This SI 142/90 contains information about modifications that have to be done on the D820-48. This set of modifications has been named Version 1.0 .

3. MODIFICATION INSTRUCTIONS

7. CUE MODULATOR 1.862.861.20

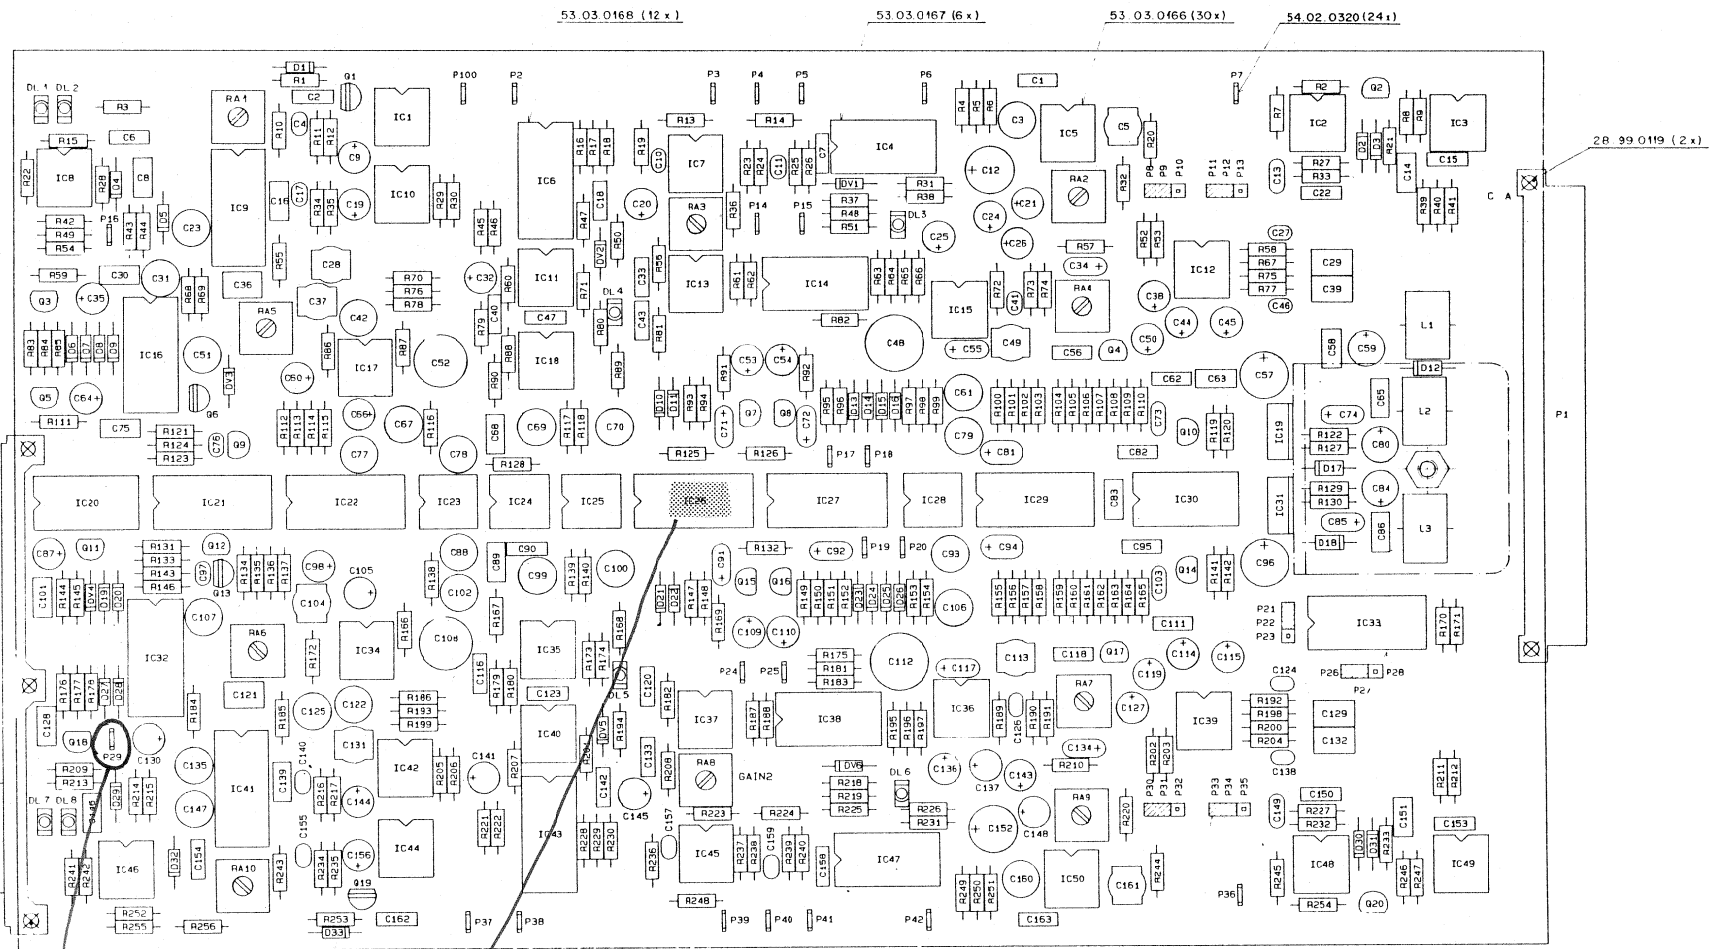
Partial misbehaviour when receiving the CP-Reset.

R 6 10k becomes 15k (57.11.3153),
R 14 3.9k becomes 4.7k (57.11.3472),
Add C 233 47 uF (59.22.3470) in parallel to R 14.

Add a resistor R 210 10k (57.11.3103) between Pin 6 and +5V
(C 06) of IC 01.
Add a capacitor C 232 0.1 uF (59.06.0104) in parallel to R14
(see schematic).

Agencja	Z. techn.	1998
Instytut	Inst.	
Adresacja	Inst.	12785
Zagraniczna	Inst.	12785
PL, BV 632, BV 640	Inst.	2.1
Instytut	Inst.	
STUWER REGENSCHOFF ZÜRICH		READ UNIT CUE TRACKS
		ESE

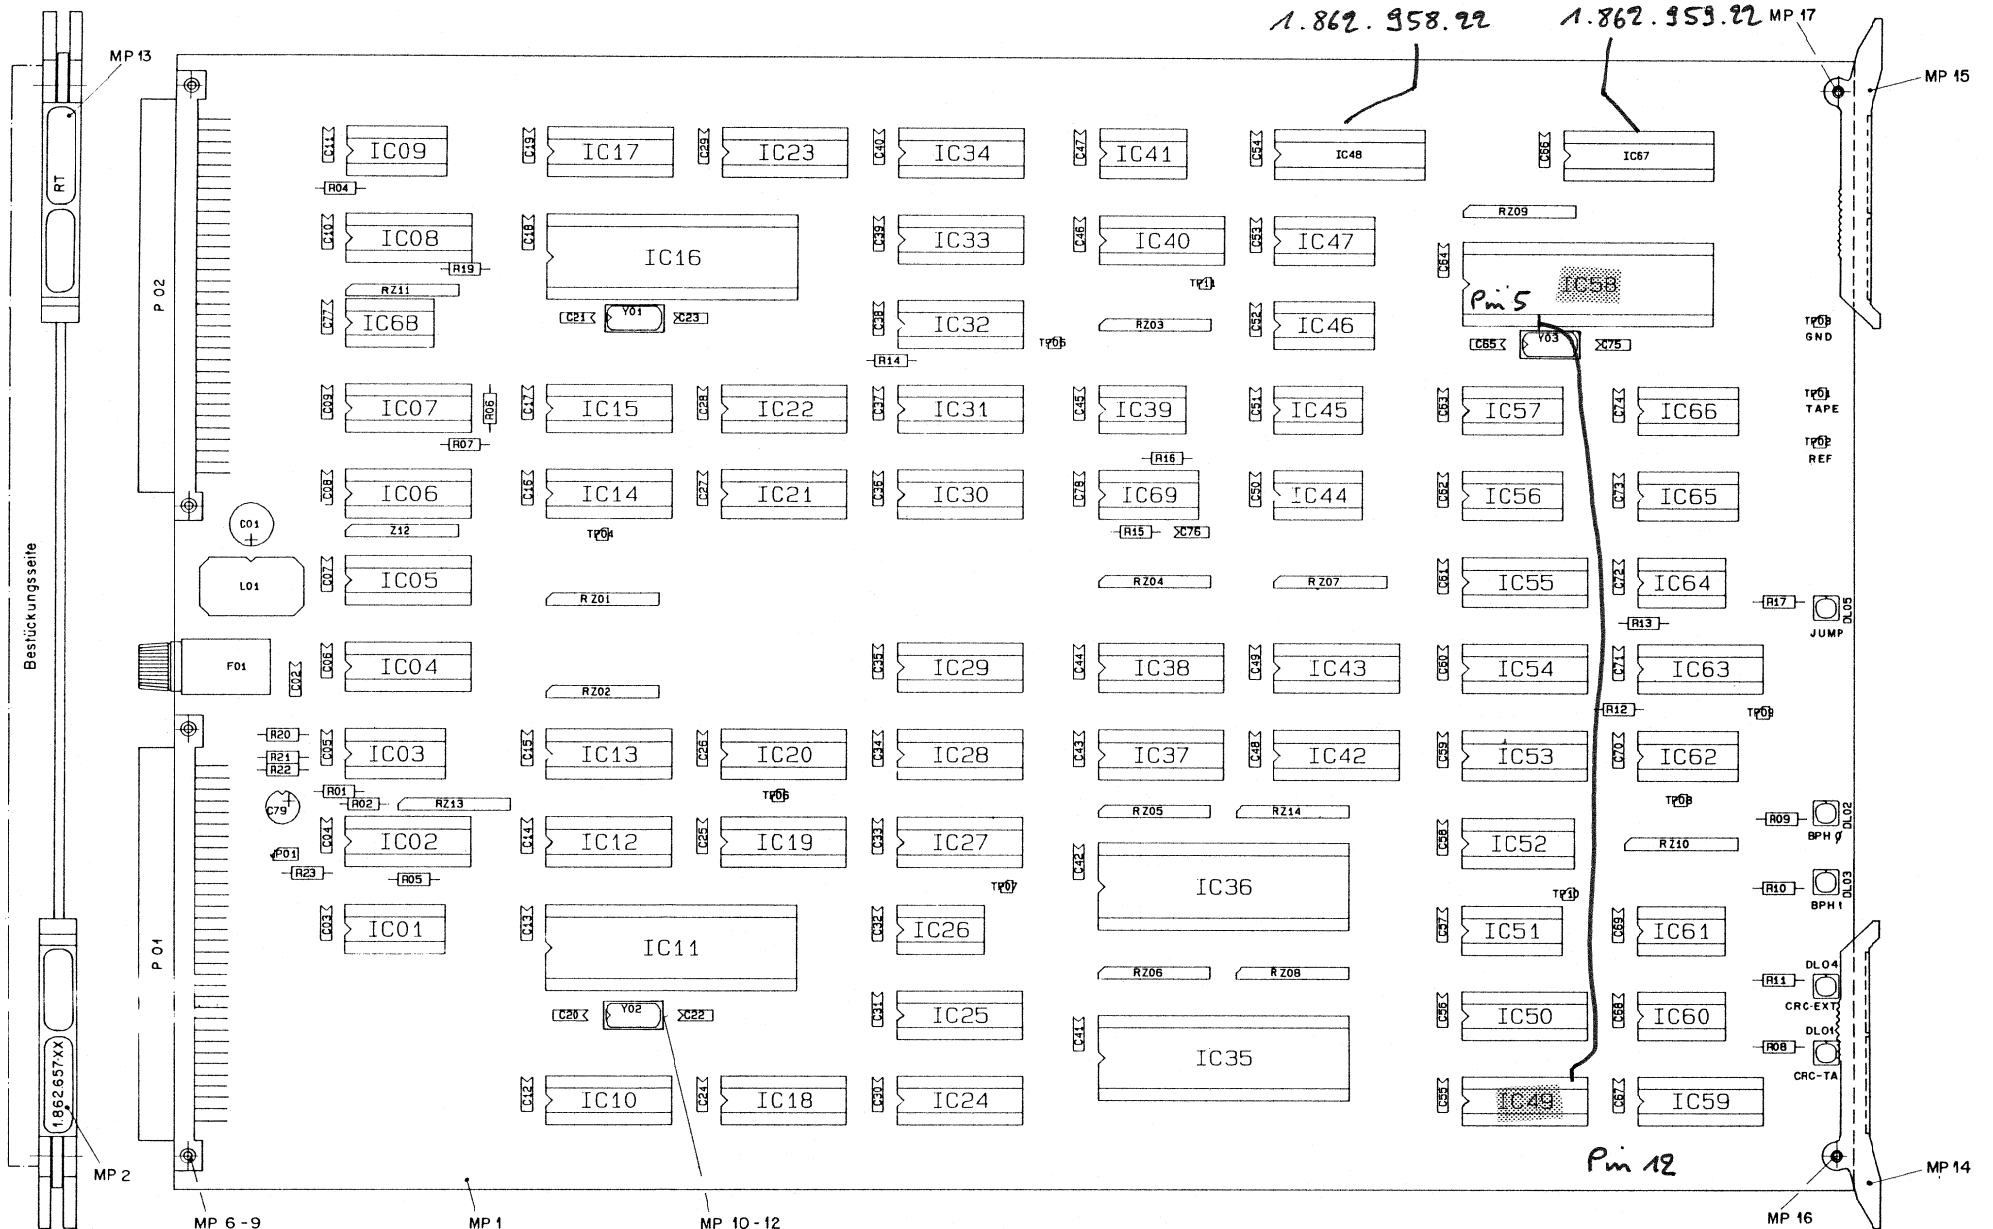
The connections from pins 8 & 9 of IC 26 (4053) to ground are missing; they must be added.

check whether pins 8 & 9
 are connected to ground!

Norm-Nr.:		Gute	
DIN-Bez.:		Ben.	
Abmessung			
Zugehörige Unterlagen	Fremdasozieranz	Maßstab	Ausgabe
PL, BV 640	=	1,3 : 1	49.6.90 <i>[Signature]</i>
Ersatz für	Ersetzt durch	Kode für	Datum
			Gez. Gebr. Ges. No.
STUDEF REGENSDORF ZÜRICH		AES INTERFACE ESE	
Bezeichnung		Nummer	
		1.862.664-21

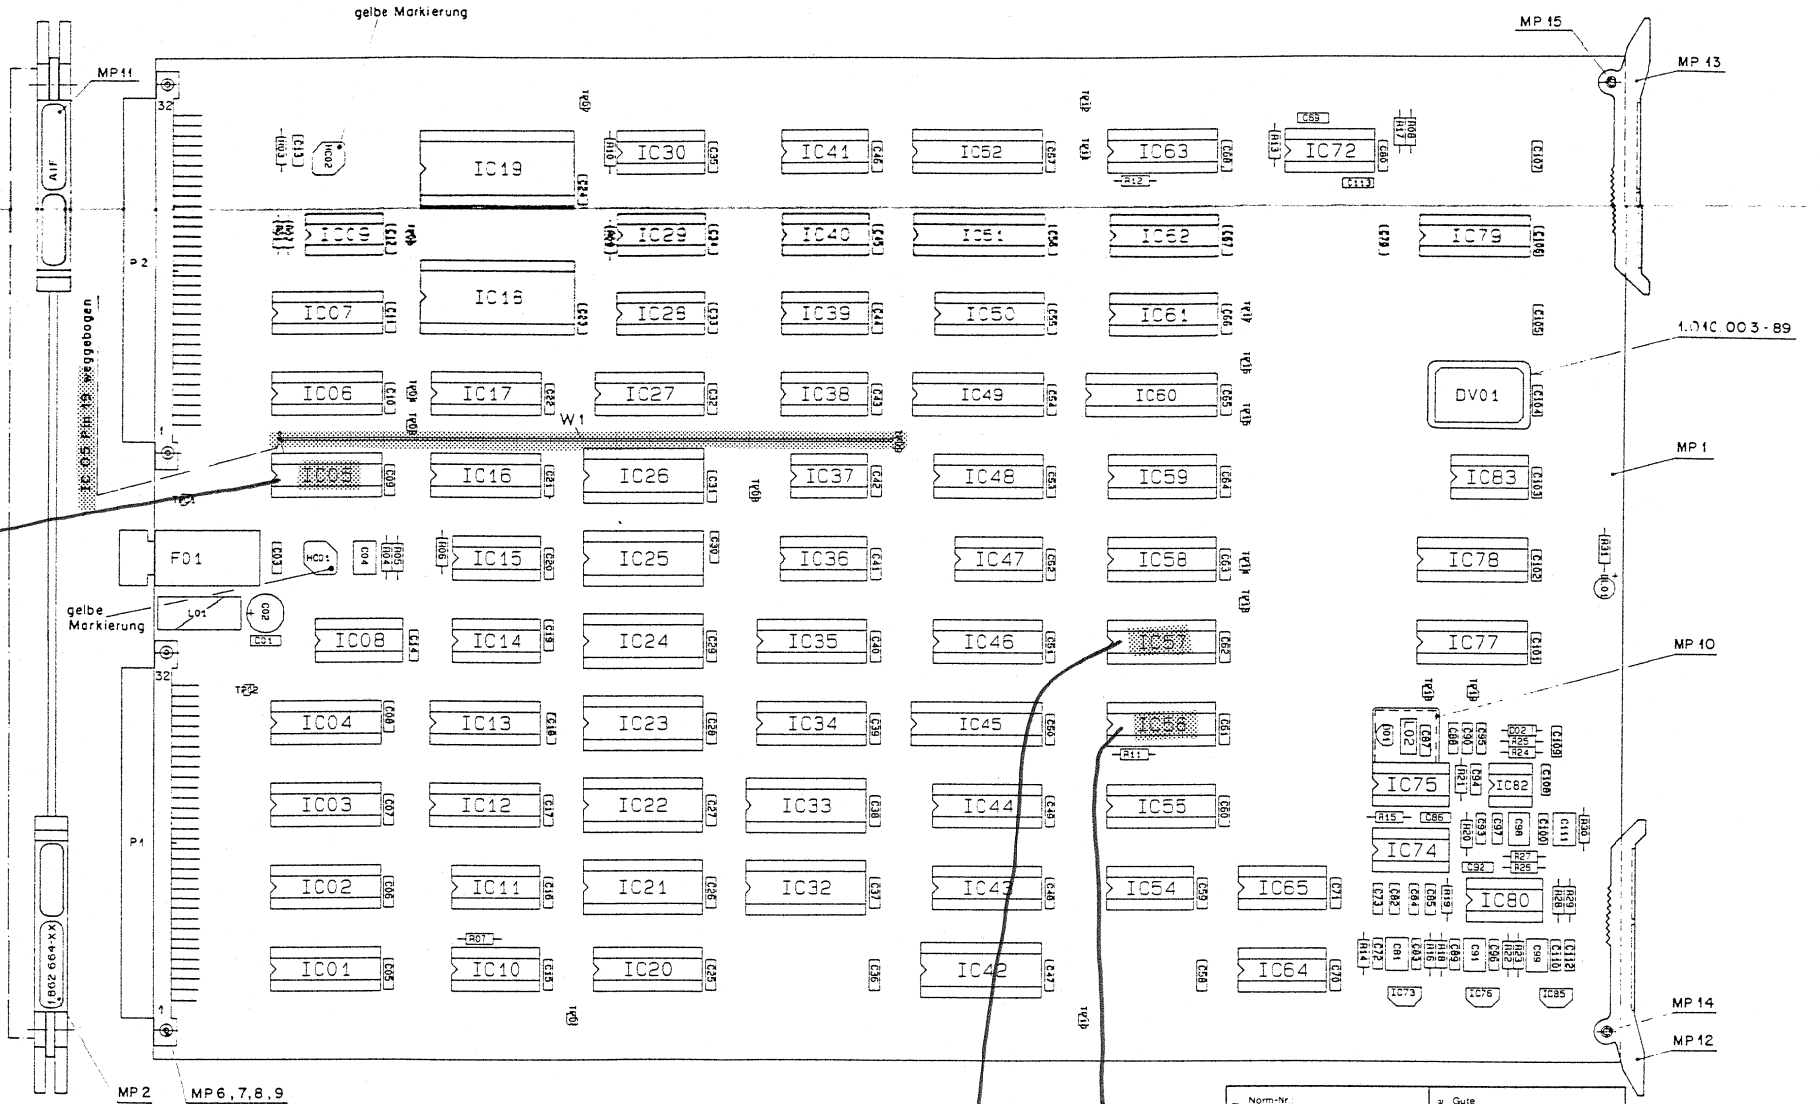
a) Software change due to a fault in the routing of channel 47 to the AES/EBU output;

- software IC 5 becomes 1.862.860.21
software IC 56 becomes 1.862.856.21
software IC 57 becomes 1.862.870.21

- Add a wire link from IC 5 Pin 19 to testpoint TP 9 (signal AES-REF). Pin 19 of IC 5 has to be taken out of the socket for this purpose. (IC 5 = PROM with software 1.862.860.21)
